ADDENDUM NO. 01

Project Name: TFSD 2023 Capital Improvements
Address: Twin Falls, Idaho

Date Issued: March 18, 2024

Addendum No. 01

Sheet A2.01 – SUPPORT SERVICE CLASSROOM TI – PLANS

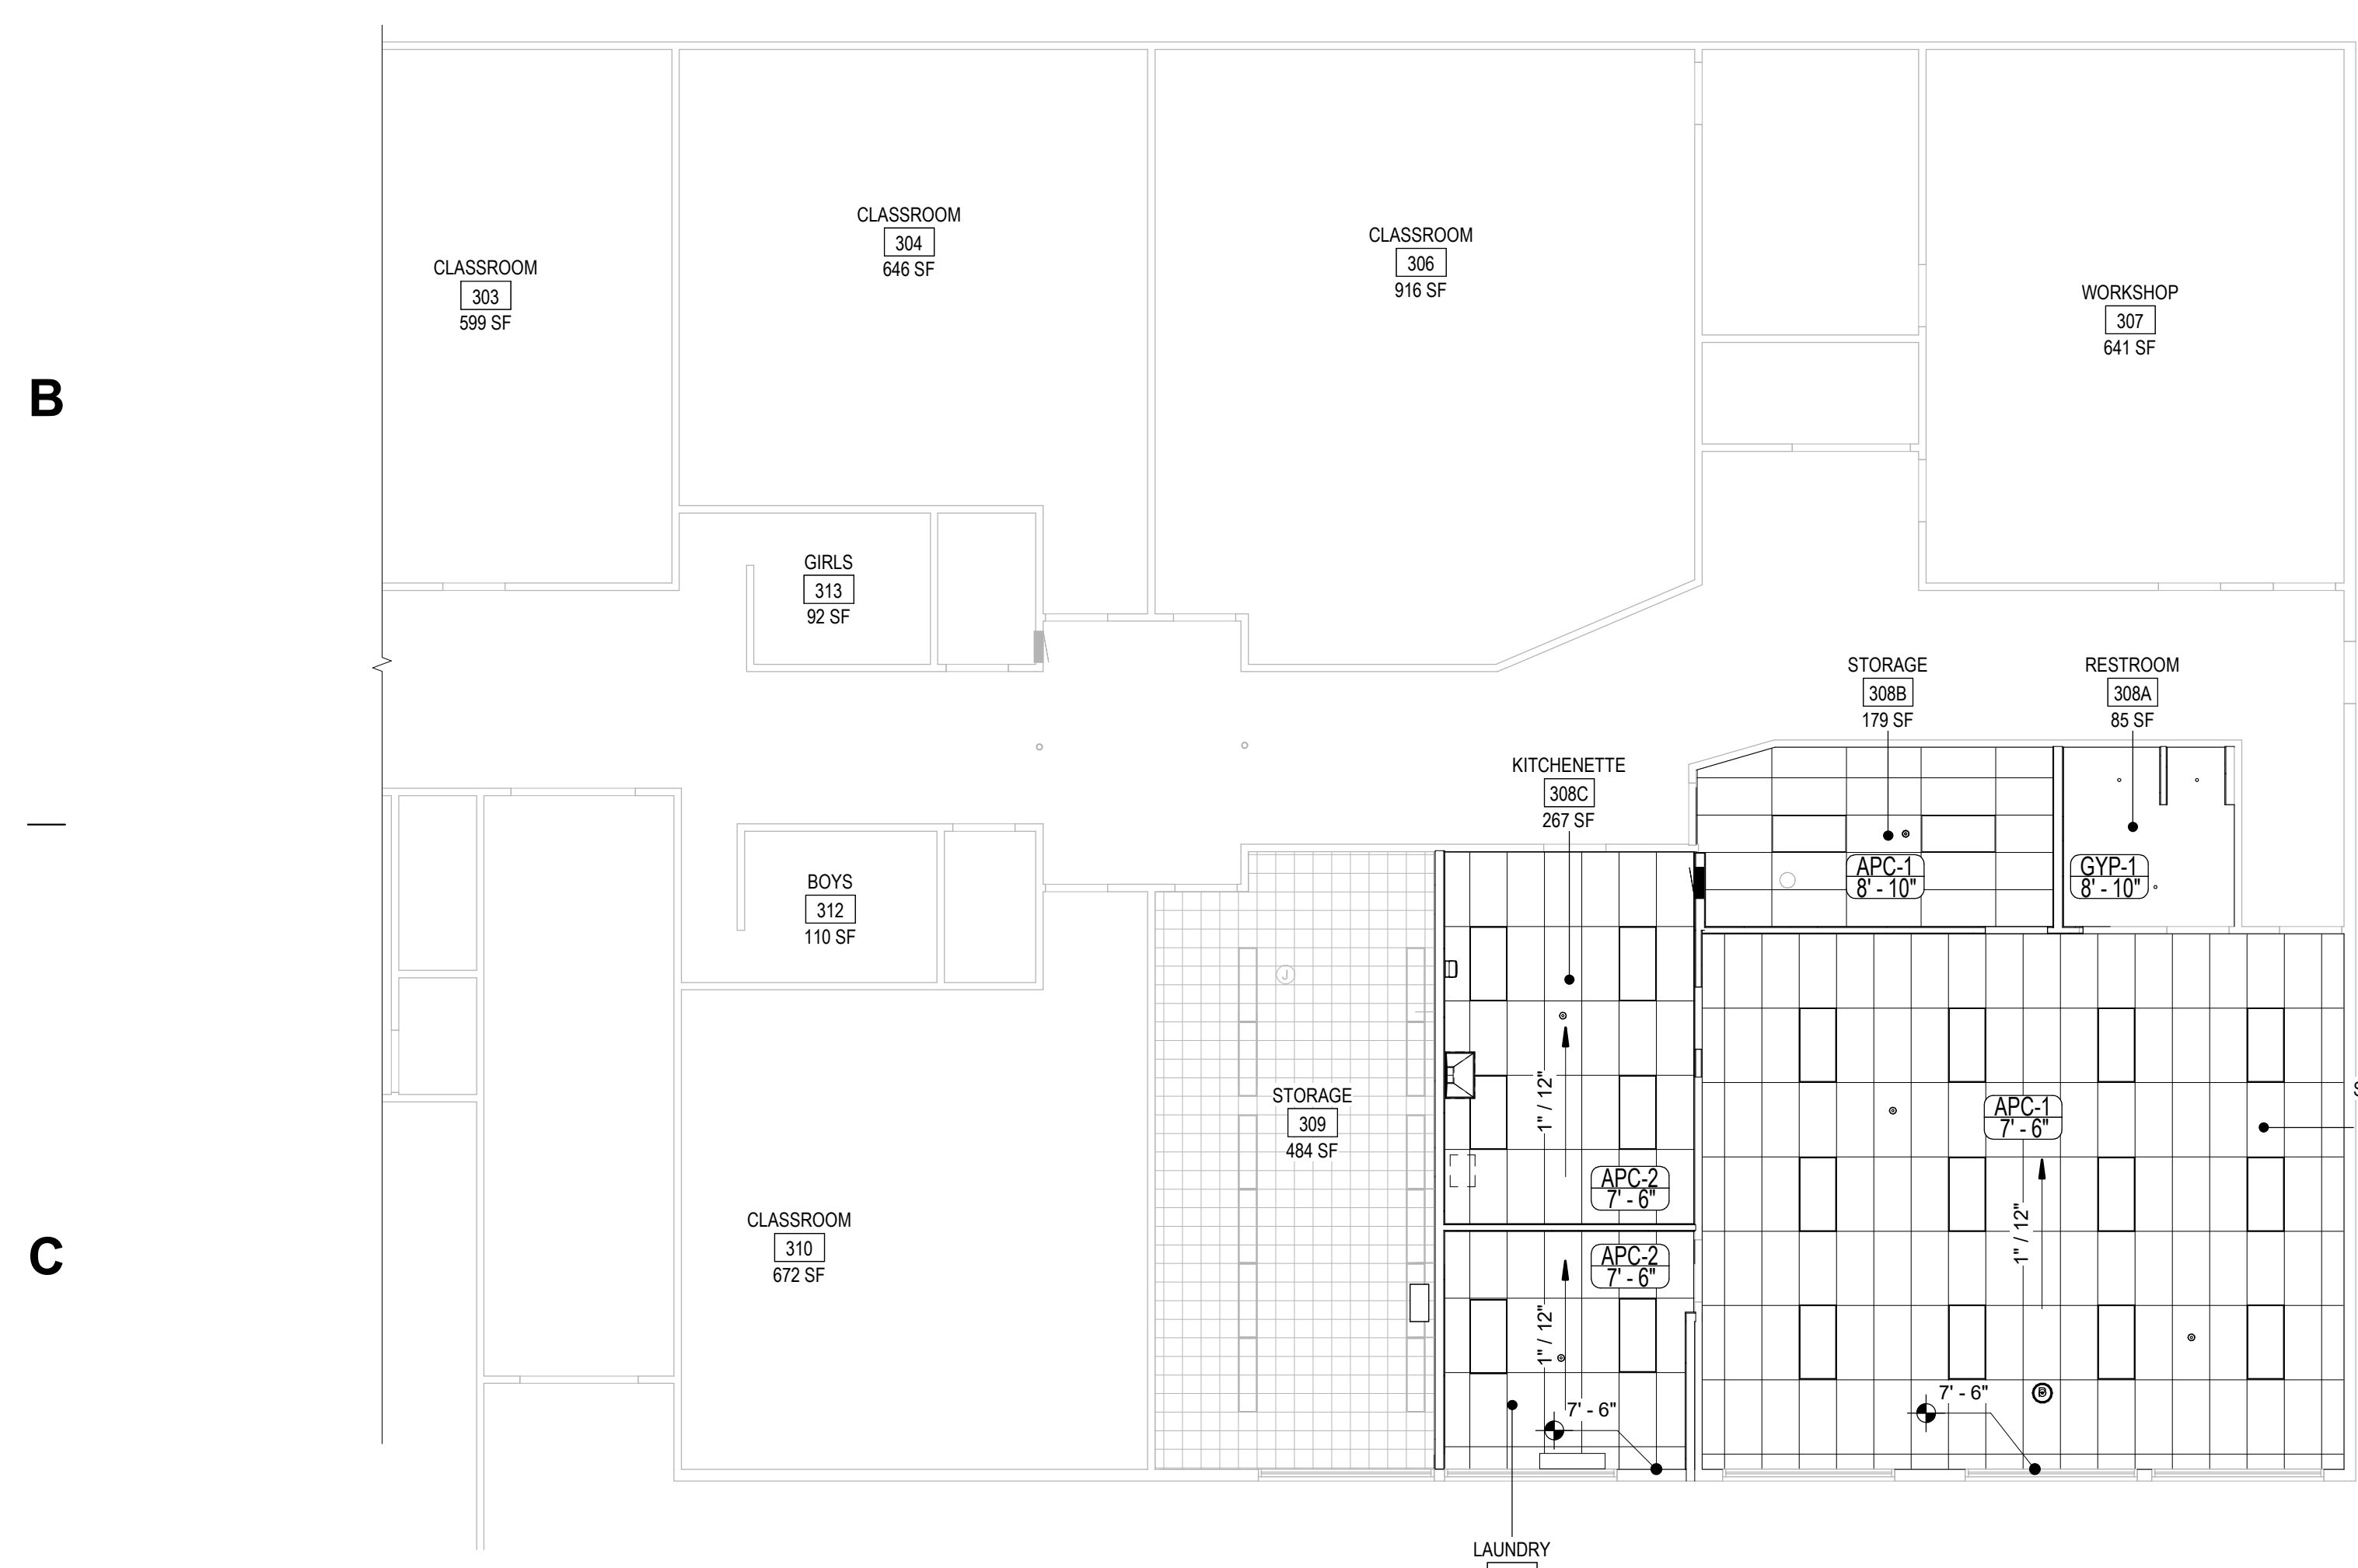
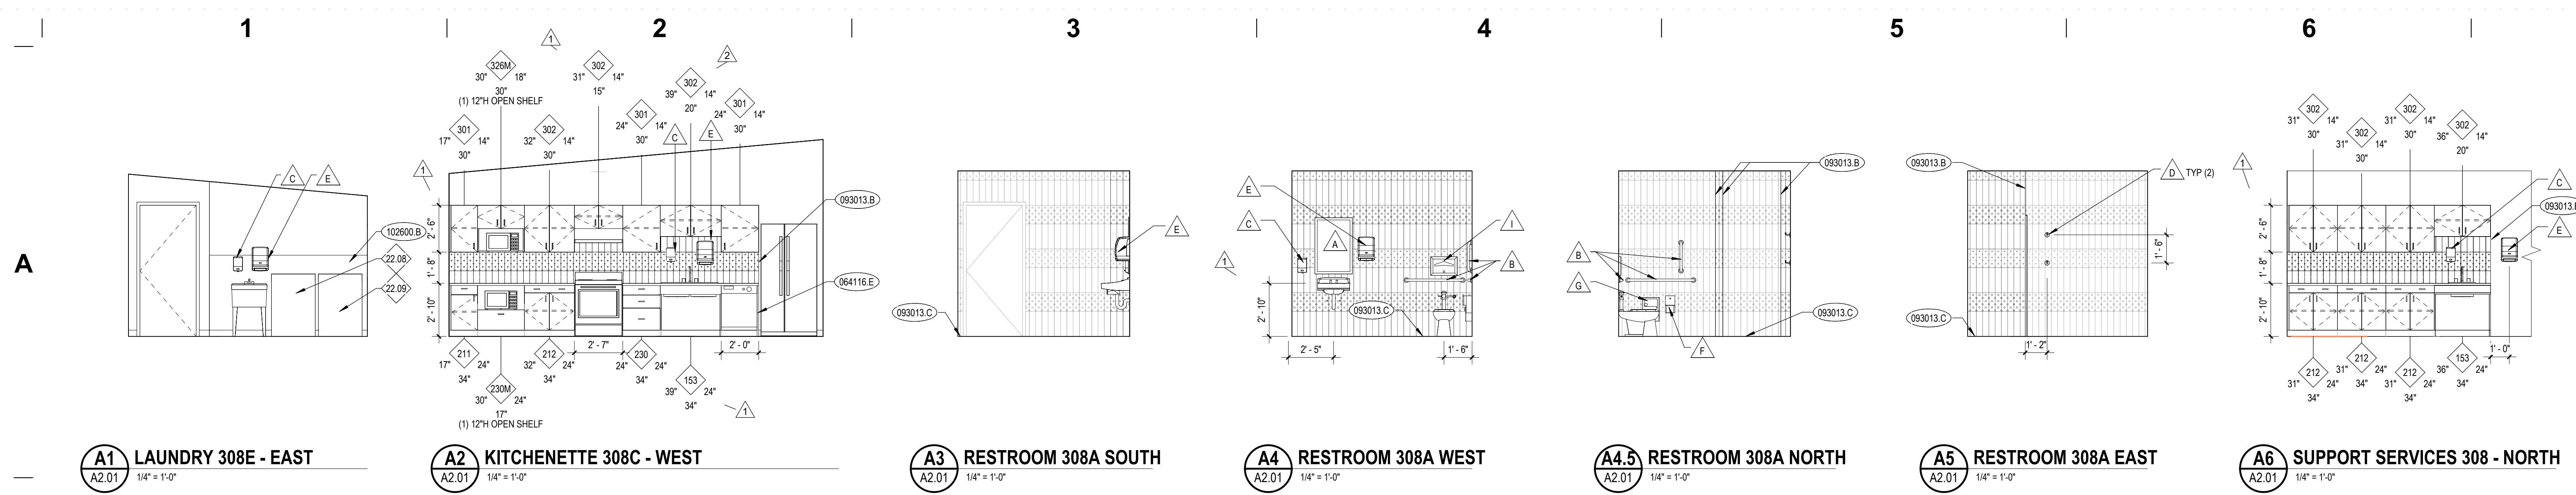
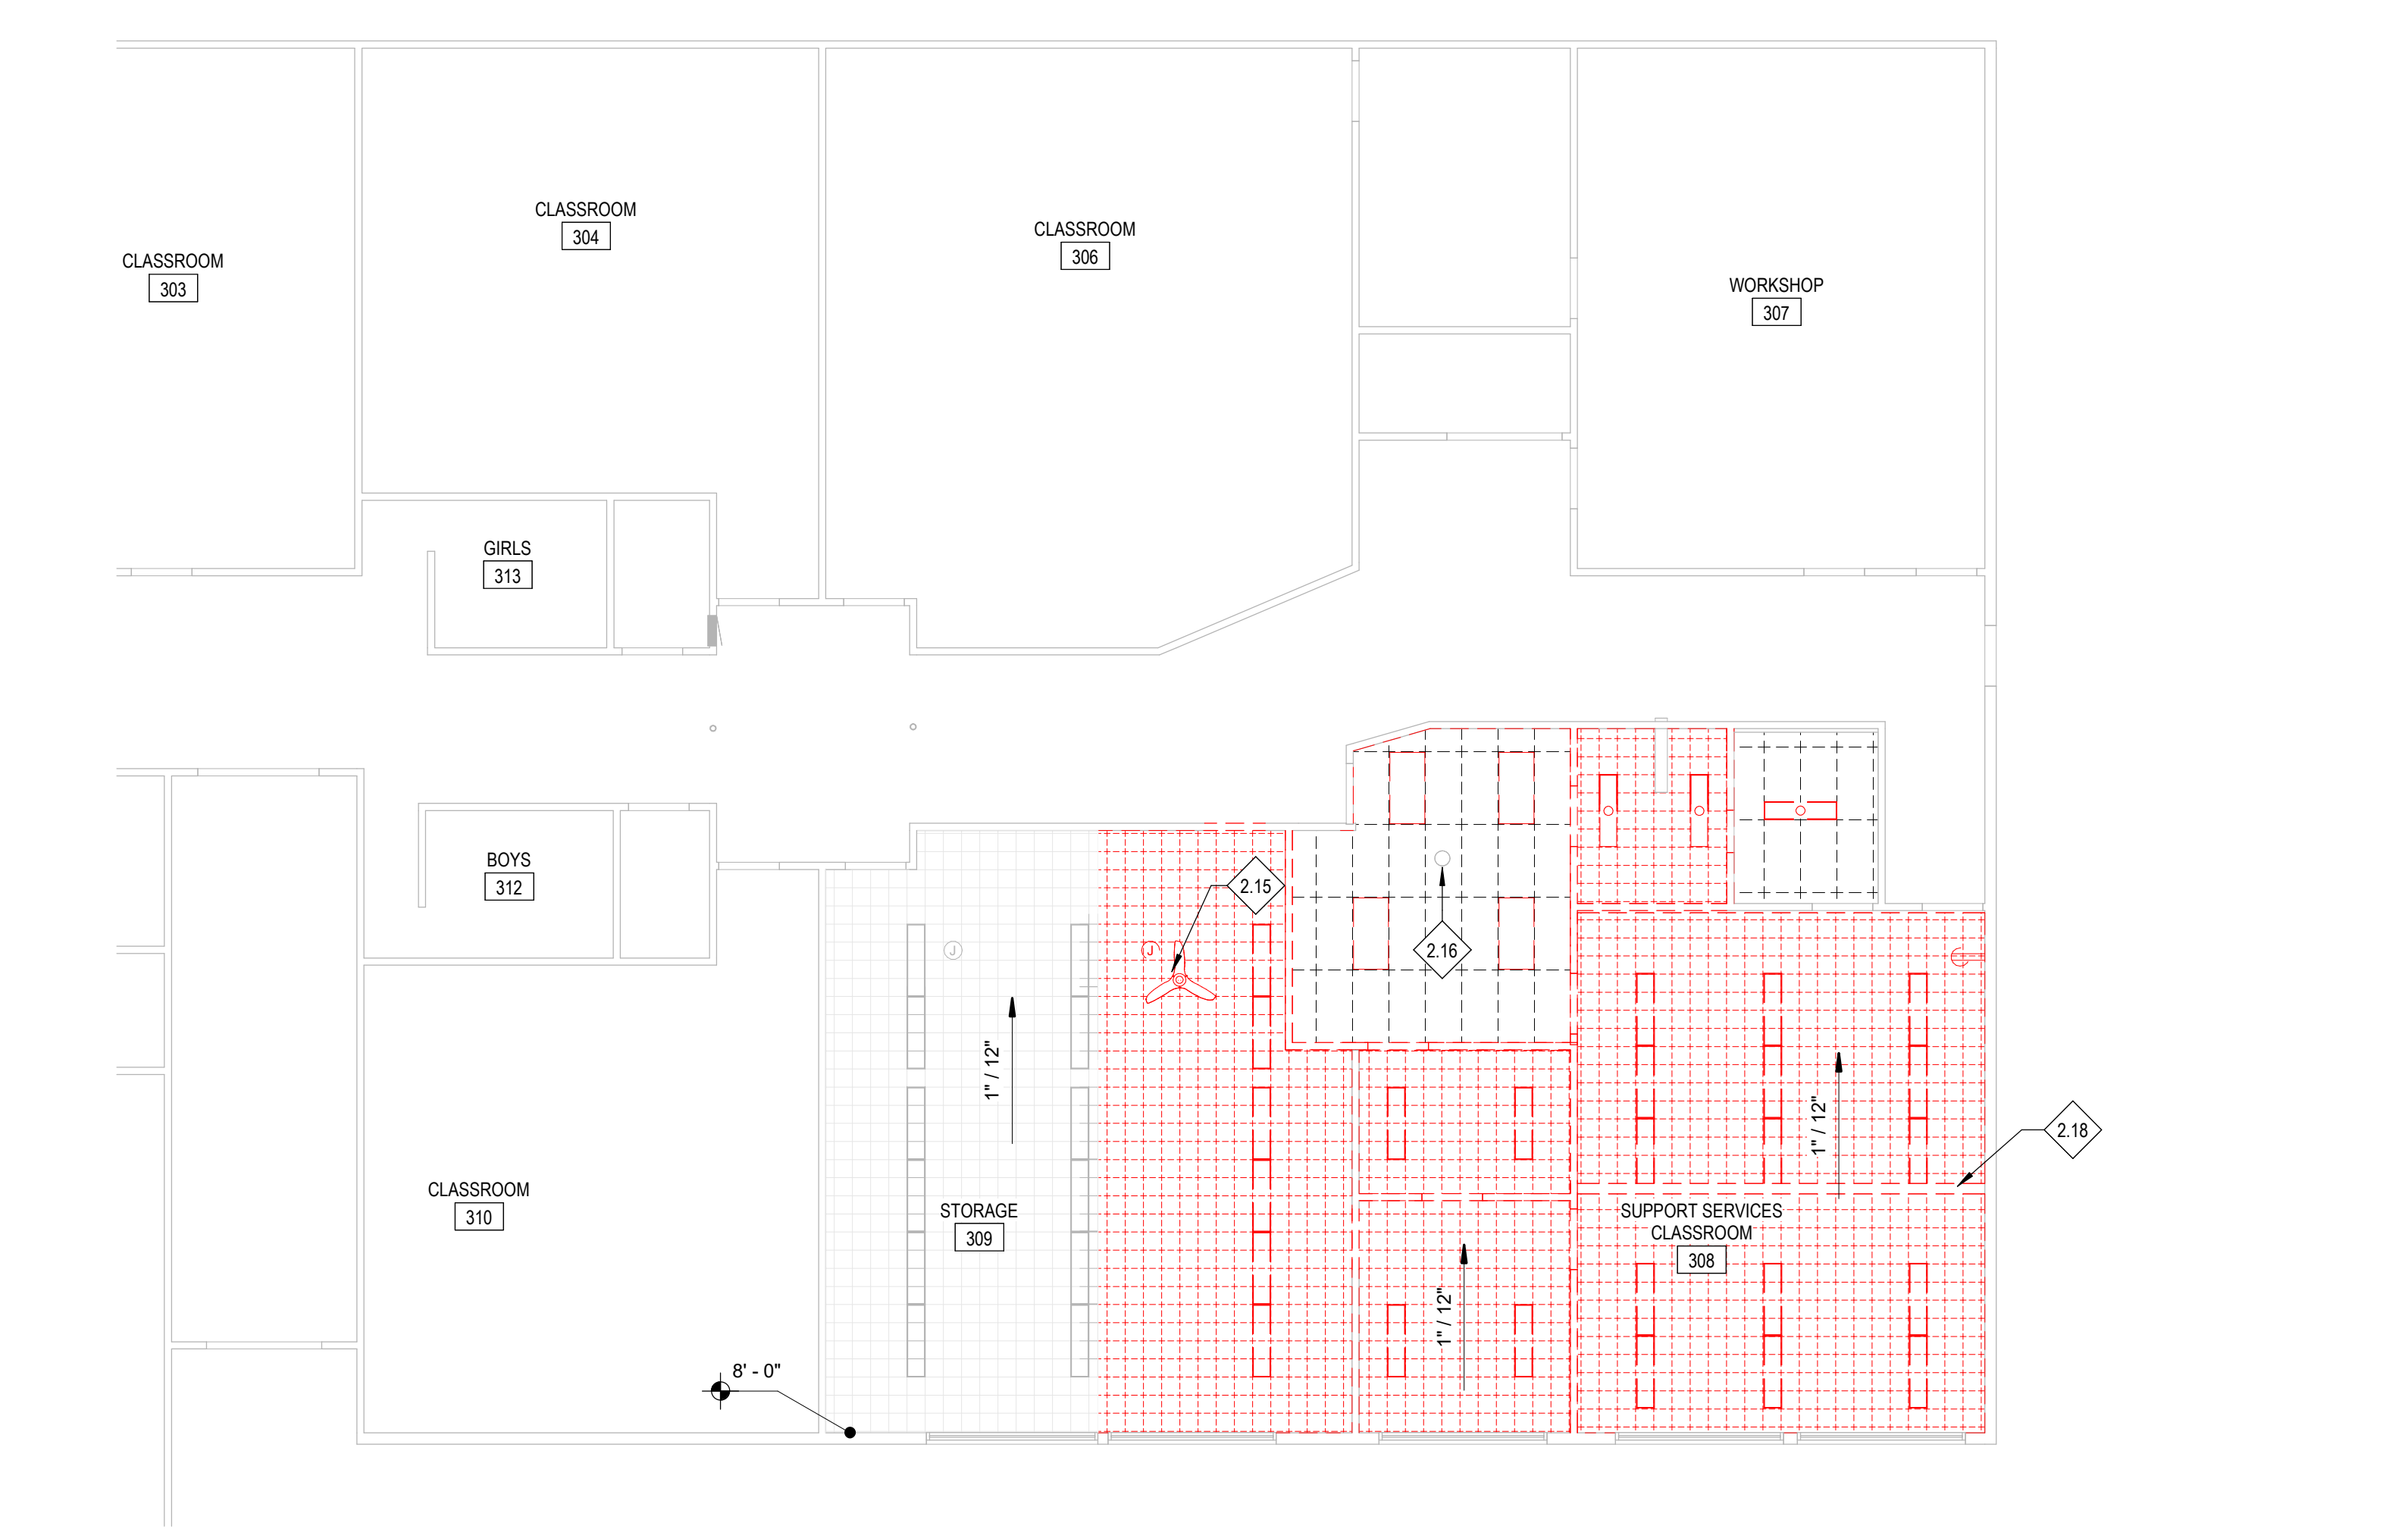
Question: O'Leary and Robert Stuart plan sheets A2.01 & A2.02 does not have a call out for the floor existing floor finishes. We would assume under all new flooring old tile or carpet to be removed? Also, is there a asbestos survey for the O'Leary, Robert Stuart, Morningside & Harrison, that we could obtain.

Revise extent of demo on existing slab to include floor at new shower within Restroom 308A and provide new concrete slab patch with slope to drain at the shower. See revised Plumbing for connection to floor drain at shower.

Response: See attached revised sheets for demo of existing floor finishes at Robert Stuart and O'Leary Middle Schools. See response from Construction Manager for materials testing report.

3.04	CONTRACTOR TO PATCH CONCRETE FLOOR FLUSH TO ADJACENT EXISTING SLAB INCLUDING SUBGRADE PREP. SEE DETAIL DS/A2.02.
3.06	CONTRACTOR TO PATCH CONCRETE FLOOR INCLUDING SUBGRADE PREP AT SHOWER SLOPED TO DRAIN WITH A FLUSH TRANSITION TO ADJACENT SLAB. SEE DETAIL DS/A2.02.03, FLOOR FINISH PLAN AND PLUMBING PLANS.
